**Overview:** Production error; immobilizer wire (orange/black) in pin position #4 instead of pin position #5. Although an effort to correct the issue was made, some quantity of harnesses did get shipped before the issue was spotted. We are advising to inspect the harness BLADE connector before attempting to install the harness and program the module.

**Overview:** The FTI-STP1 harness may require modification for use in **automatic transmission (AT)** applications, some of the product was able to be modified before release, but a small quantity was released before being able to be modified internally.

## FTI-STP1: Installation and Configuration Notes

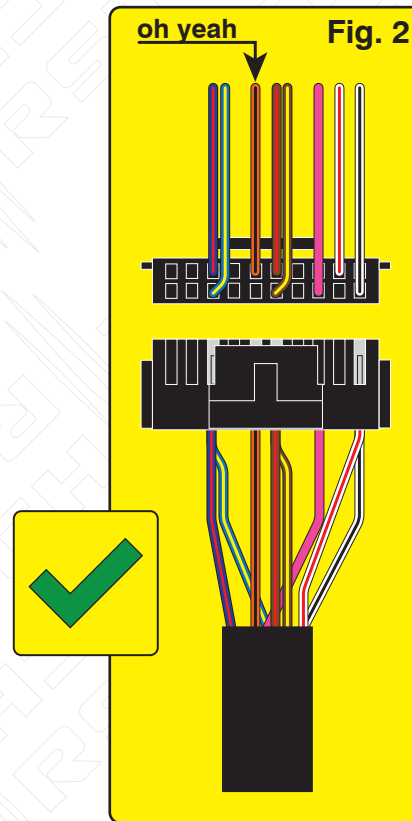
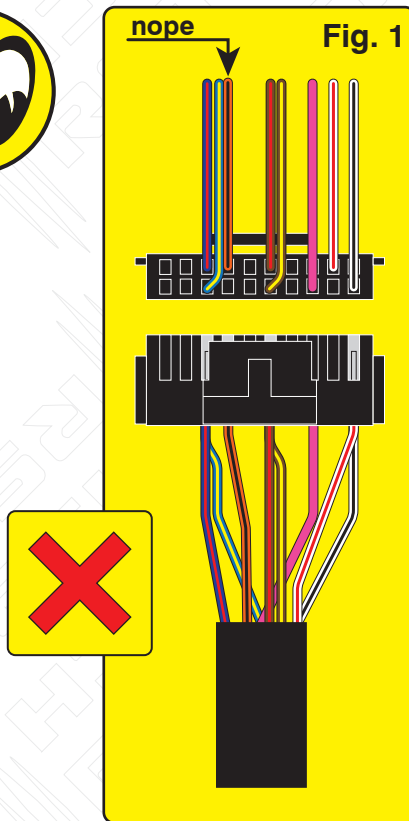
**Issue:** Module fails to program to vehicle, will not allow the vehicle to be remote started.

**Correction:** Step 1.) Locate the orange/black wire and confirm whether it is positioned as illustrated in Fig. 1 or Fig. 2. If the wire is as illustrated in Fig.1, proceed with Step 2 through 5 and complete the repair procedure outlined, if the wire is as illustrated in Fig. 2, correction is not necessary, proceed with harness installation and module programming.

**Step 2.)** Using a pick, lightly depress the catch that secures the terminal in the housing then remove the wire and terminal from the housing.

**Step 3.)** Using a fine tip razor or utility knife, insert the blade beneath the terminal catch and raise it slightly, so that it can be reused to secure the terminal when reinserted into the BLADE connector housing.

**Step 4.)** Refer to Fig. 2 for correct position of the orange/black wire (next to brown/red) then reinsert the terminal, pressing lightly until the catch 'snaps' into place, securing the terminal in the connector housing.

**Step 5.)** The repair is complete, proceed with installation and programming.

**MODIFICATION REQUIRED FOR AUTOMATIC TRANSMISSION APPLICATIONS ONLY**

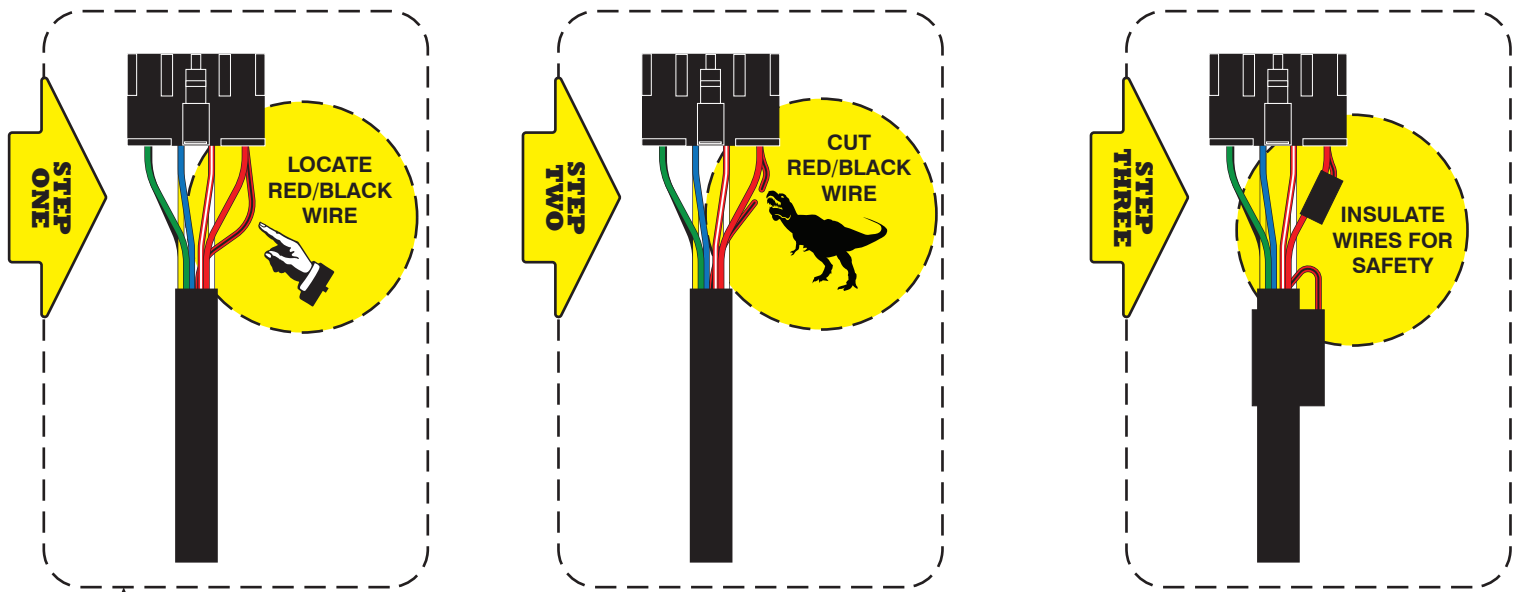
**Issue:** The FTI-STP1 T-harness has been designed to be compatible with AT (automatic transmission) & MT (manual transmission) applications, but due to a production oversight, the selection mechanism was defaulted to MT mode.

Using a harness configured for an MT application, in an AT equipped vehicle, could result in vehicle module damage, it is advised that the harness be returned to AT mode before installation in vehicles equipped with an automatic transmission.

**Correction:** Locate the **red/black (+ Clutch)** wire provided in the CN1 connector of the main harness assembly. Cut the **red/black** wire, either flush to the CN1 connector, or leaving enough wire exposed so that you can insulate and secure the ends of the wire that remain after cutting. Insulate each of the remaining ends of the **red/black** wire and secure to prevent any possibility of a short circuit.

If the red/black wire already been disconnected, no further modification is required for AT equipped vehicles.
